Access Compliance Report

Public Rights-of-Way

Intersection ID: 52448	Main Street: WOODWARD_AV	Cross Street: DOUBLE_OAKS_RD	Location: NW
ADA ID: 8301A9D7E4CC	Ramp Type: Directional1	Initial Pass/Fail: Pass	Overall Compliance: No
Severity Score: 15.25			
Codes/Mitigation Info/Possible Solution		Field Measurements/Component Compliance

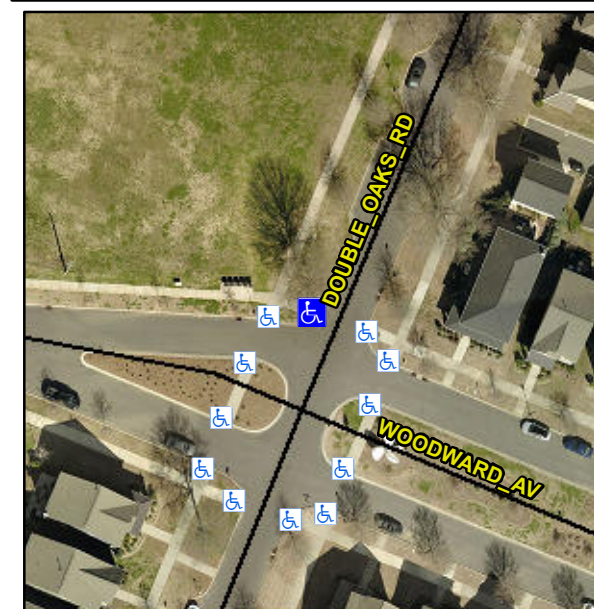
R304.5.3, R302.7.2

Compliance	Description	Data	Compliance	Description	Data
N/A	Ramp Length (in)	96.0	Yes	Grade Break?	Yes
Yes	Ramp Width (in)	65.5	No	Grade Break Slope (%)	8.1
Yes	Ramp Slope (%)	4.1	No	Grade Break XSlope (%)	3.9
No	Ramp XSlope (%)	2.6			
Yes	Flare Type LT	N/A	Yes	Flare Type RT	N/A
N/A	Flare Slope LT (%)	N/A	N/A	Flare Slope RT (%)	N/A
N/A	Flare Traversable LT?	No	N/A	Flare Traversable RT?	No
Yes	Landing Length (in)	64.5	Yes	DWS Provided?	Yes
Yes	Landing Width (in)	74.0	Yes	DWS Contrast?	Yes
Yes	Landing Slope (%)	1.5	Yes	DWS Length (in)	24.0
No	Landing X Slope (%)	3.3	Yes	DWS Full Width?	Yes
N/A	Landing Curb? (Y/N)	No	Yes	DWS Offset LT (in)	0.0
N/A	Shared Landing?	No	Yes	DWS Offset RT (in)	17.5
Yes	Gutter Ponding?	No	Yes	Gutter Slope (%)	1.8
No	Gutter Lip Ht (in)	1.5	Yes	Gutter X Slope (%)	1.2
N/A	Painted X Walk1?	No		Road Slope (%)	7.4
	X Walk 1 Direction	To E		Road X Slope (%)	1.5
	X Walk 1 Width (in)	N/A		Clear Space?	Yes

X Walk 1 Slope (%)	7.4	N/A	Clear Space to XWalk (in)	N/A
	X Walk 1 X Slope (%)	1.5	Yes	Storm Grate/Utility Hazard?	No
N/A	Ramp inside XWalk1?	N/A		Storm Grate/Utility Type	
Yes	Any Obstructions?	No			N/A
	Obstruction Type		Yes	Surface Condition? (G/P)	Good
			N/A	Curb Slope (%)	3.8

**Remove & Replace Entire Ramp.
Grind Gutter Lip.**
